**ADDENDUM
NO. 2**

January 16, 2023

**The Riviera Club Aquatics Center
5640 North Illinois Street
Indianapolis, IN 46208**

This Addendum consists of Pages ADD 2-1 through ADD 2-2, RFI List (Questions & Answers) and attached Schmidt Associates Addendum No. 2 Dated January 12, 2023, Consisting of 45 pages, Specification Sections: 061753 – Shop-Fabricated Wood Trusses, 075423 – Thermoplastic Polyolefin (TPO) Roofing, 081613.99 – Fiberglass Reinforced Plastic Doors and Frames, 093000 – Tiling, 105113 – Metal Lockers, 105126.99 – Plastic Lockers, 224000 – Plumbing Fixtures, 224700 – Drinking Fountains and Water Coolers, 237313 – Fixed Plate Air to Air Energy Recovery Unit, 263600 – Transfer Switches, 265119 – LED Interior Lighting, 265219 – Emergency Exit Lighting, 265619 – LED Exterior Lighting, 270500 – Common Work Results for Communication Systems, 270526 – Grounding and Bonding for Communications Systems, 270528 – Pathways for Communications Systems, 270553 – Identification for Communications Systems, 271313 – Communication Copper Backbone Cabling, 271513 – Communication Copper Horizontal Cabling, 280528 – Pathways for Electronic Safety and Security, 280544 – Sleeves and Sleeve S

1B ROOF TYPE - SP-2
1 1/2" = 1'-0"

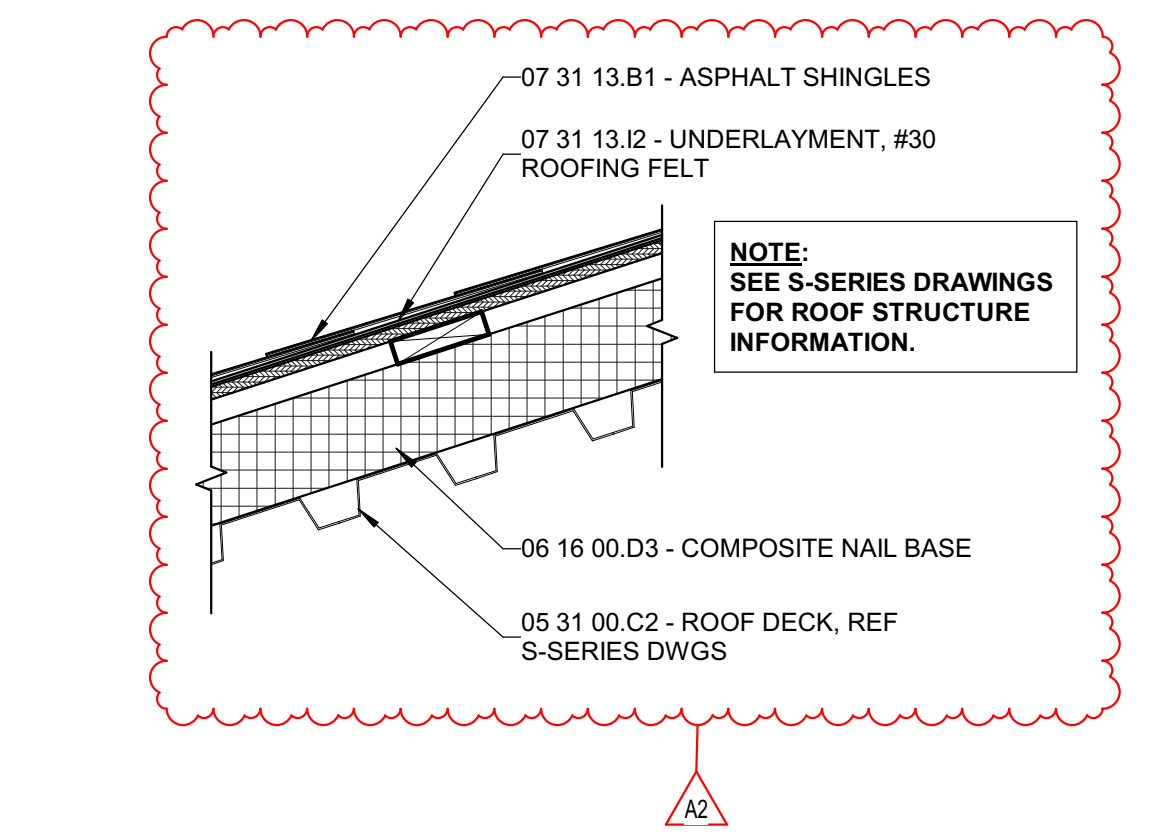
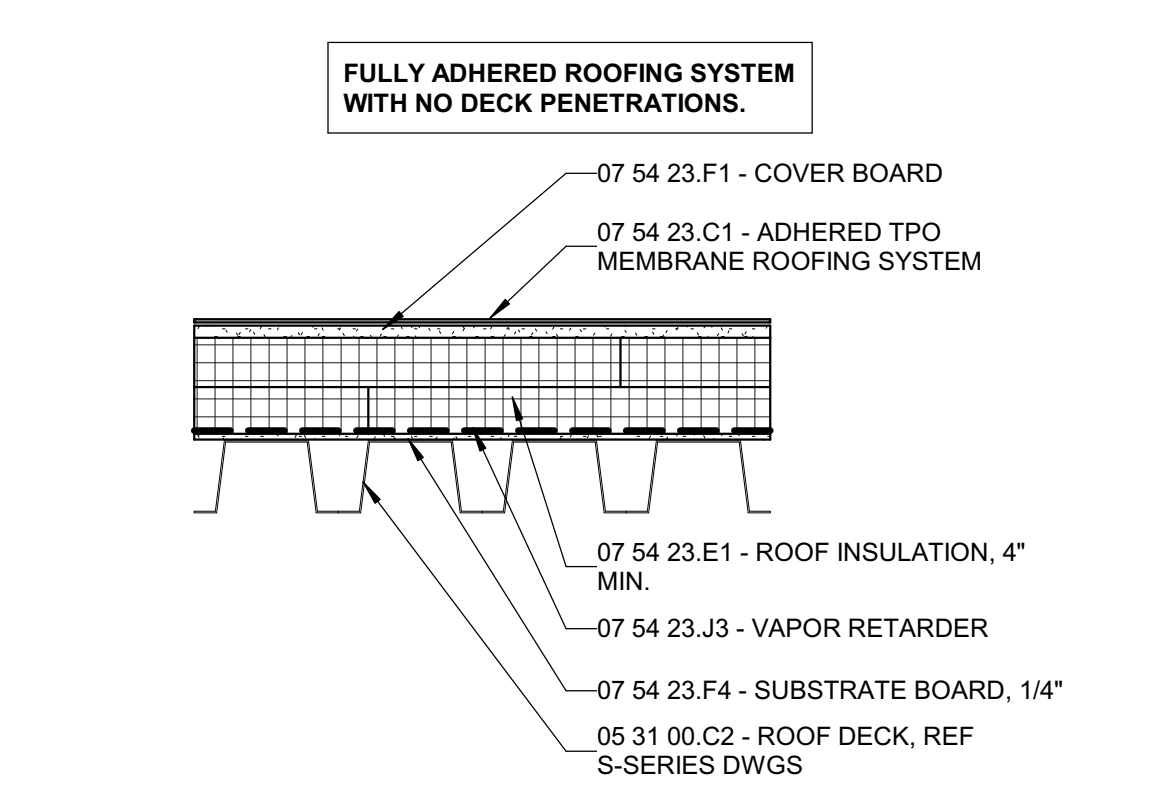
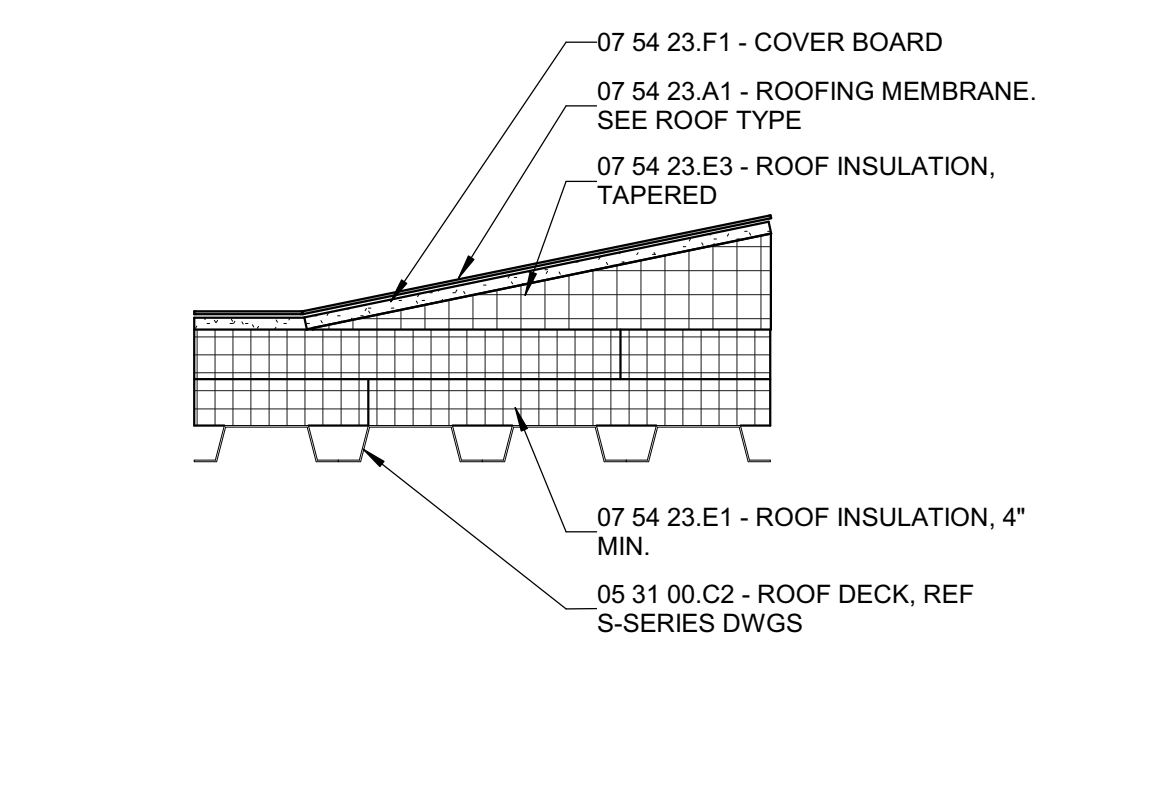
| ID | Question | Answer |
|--------------------|--|--|
| Bid RFI-010 | Roof Assembly SP-2 / 1B on sheet AR100 - This roof assembly has a note that indicates there should be no penetrating fasteners. Spec section 07 54 23 3.4.2 indicates the substrate board should be fastened to the metal deck. Please indicate which is correct? (NRCA does not recommend adhering directly to the metal deck. In this instance, it would be recommended to fasten the substrate to the deck using stainless steel fasteners and adhering the remainder of the roof assembly to the vapor retarder with low rise foam adhesive) | Response (Answered) from: Brandon Fox (SAI) Remarks: No penetrating fasteners above pool environment. |
| Bid RFI-011 | The substrate board in specification 07 54 23 2.5.A states it should be 5/8" thick. Roof assembly SP-2 on sheet AR100 indicates the substrate board to be 1/4". We assume 5/8" is the desired thickness. Please confirm. | Response (Answered) from: Brandon Fox (SAI) Remarks: Substrate boards as specified, with the exception of the bottom layer of substrate board at pool environment which can be 1/4" as indicated. |
| Bid RFI-015 | Can the fastening method of the roof assemblies SP-2 and SP-1 be clarified? Spec section 07 54 23 3.6.H indicates to fasten all layers of the insulation but paragraph 07 54 23 3.6.H.2 indicates to fasten the bottom layer and adhere the top layers. (Adhering a roof assembly with low rise foam adhesive is very expensive. The most cost effective assembly while still obtaining a thermal break would be to adhere an HD ISO cover board only and fasten all layers of insulation) | Response (Answered) from: Brandon Fox (SAI) Remarks: To be addressed in Addendum No. 1. |

1. DELETE AND REPLACE Paragraph 2.5.A. as follows:
“A. Substrate Board: ASTM C 1177/C 1177M, glass-mat, water-resistant gypsum substrate, 1/4 inch thick.”
2. DELETE Paragraph 2.5.B. in its entirety.
3. DELETE Text “each layer of insulation” from Paragraph 3.6.H.

1A LOCKER TYPE "Y"
1" = 1'-0"

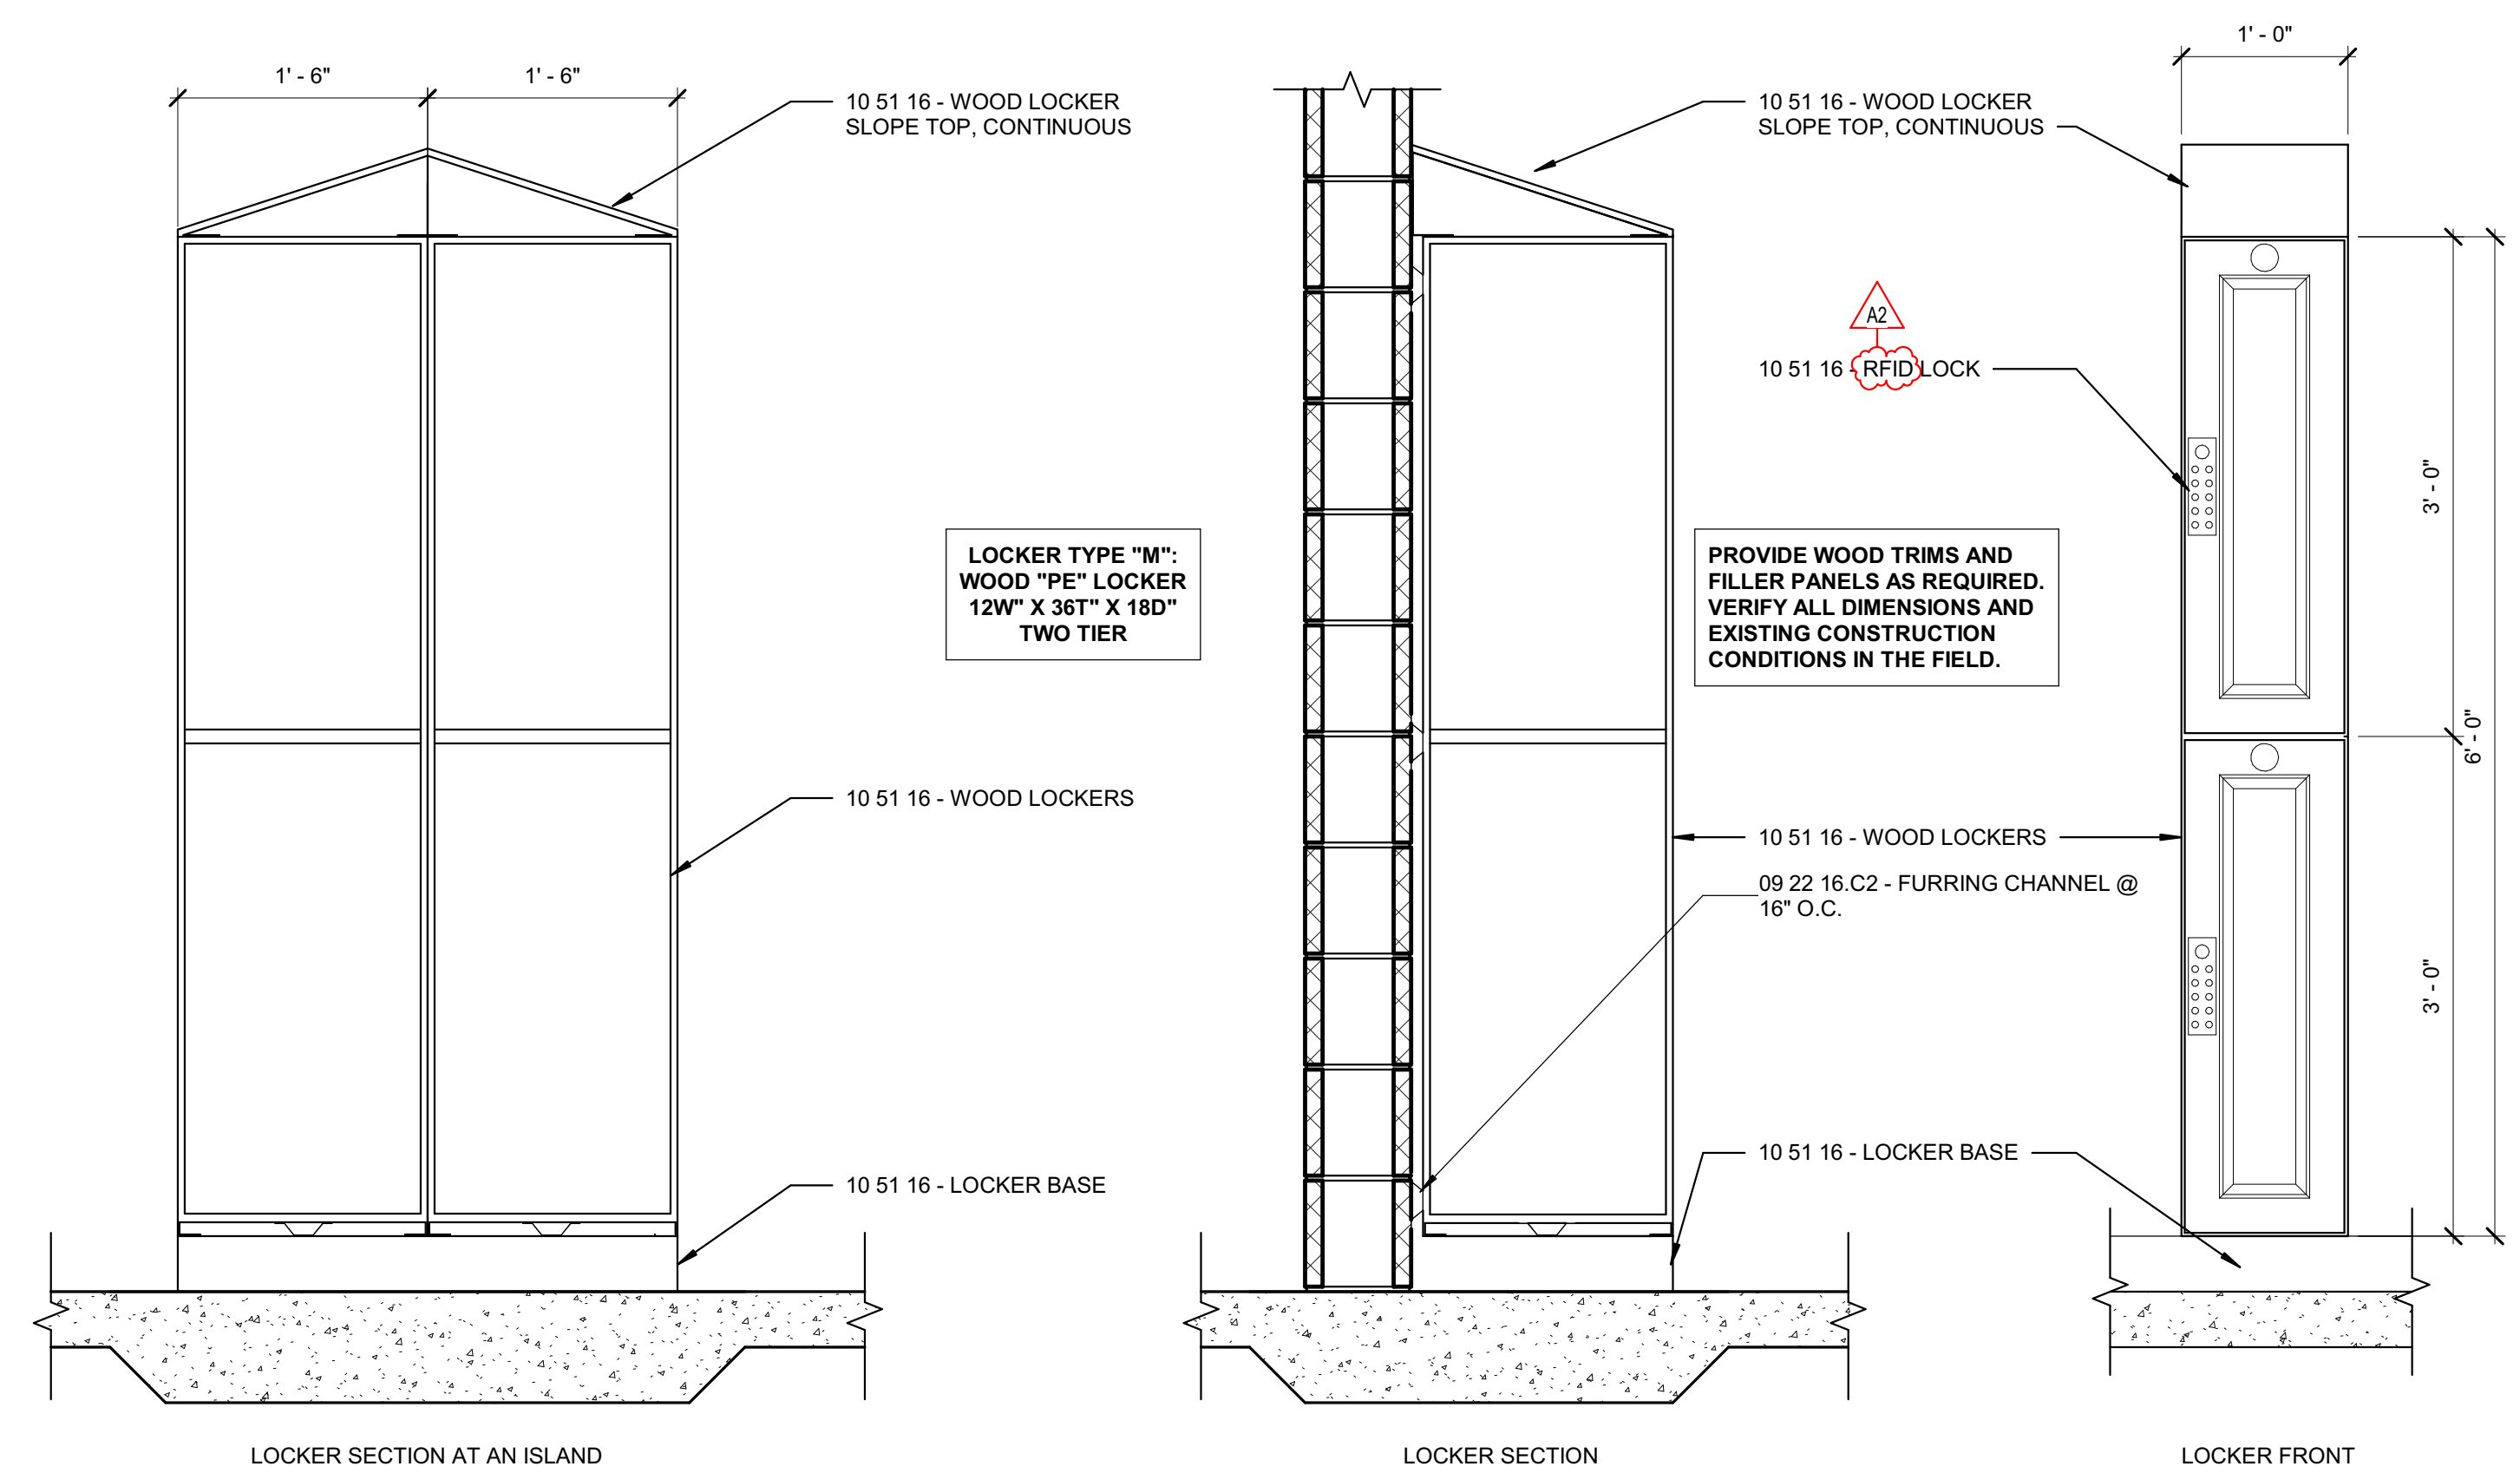
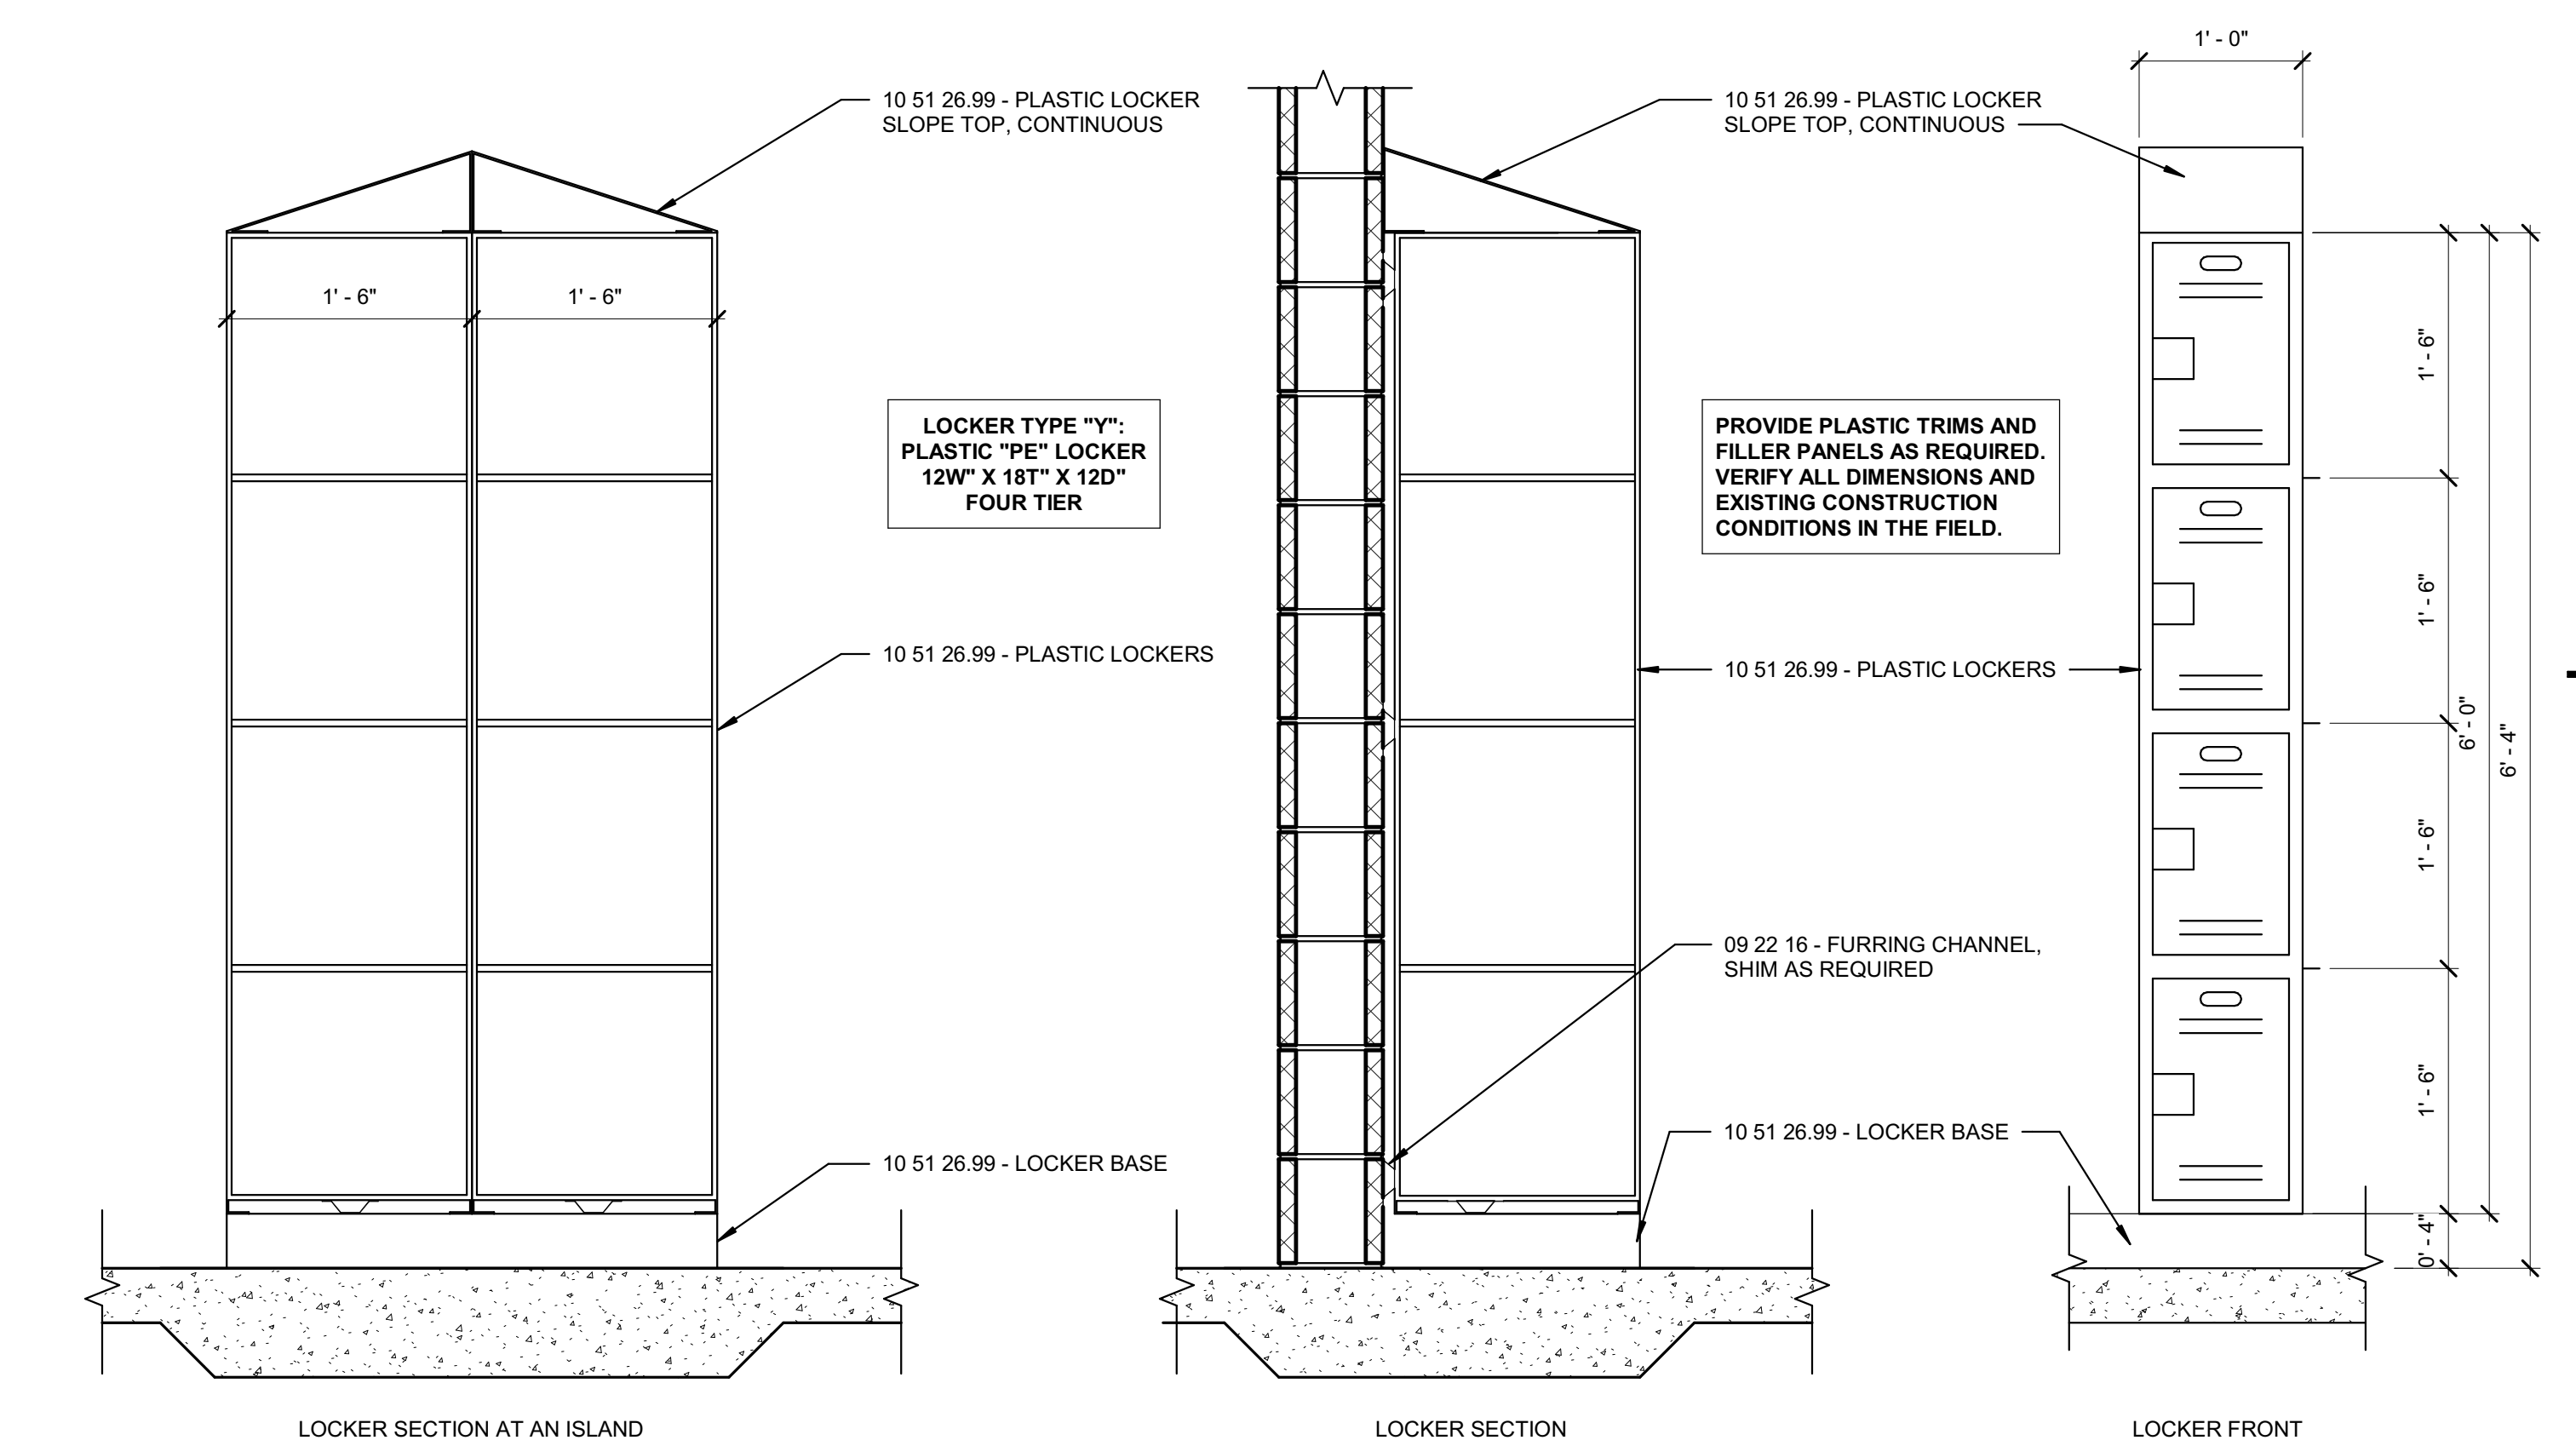
| ID | Question | Answer |
|--------------------|---|---|
| Bid RFI-024 | Plastic locker type Y is shown as a 4 tier unit on sheet A401. Specs call for 2 tier. Please clarify which is correct. | Response (Answered) from: Brandon Fox (SAI) Remarks: To be addressed in Addendum No. 1. |

1. DELETE AND REPLACE Paragraph 2.2.B. as follows:
“B. Locker Arrangement: Multiple-tier as indicated on Drawings
2. MODIFY Paragraph 2.2.E. as follows:
Add text “Refer to drawings for locations where RFID locks are required.”
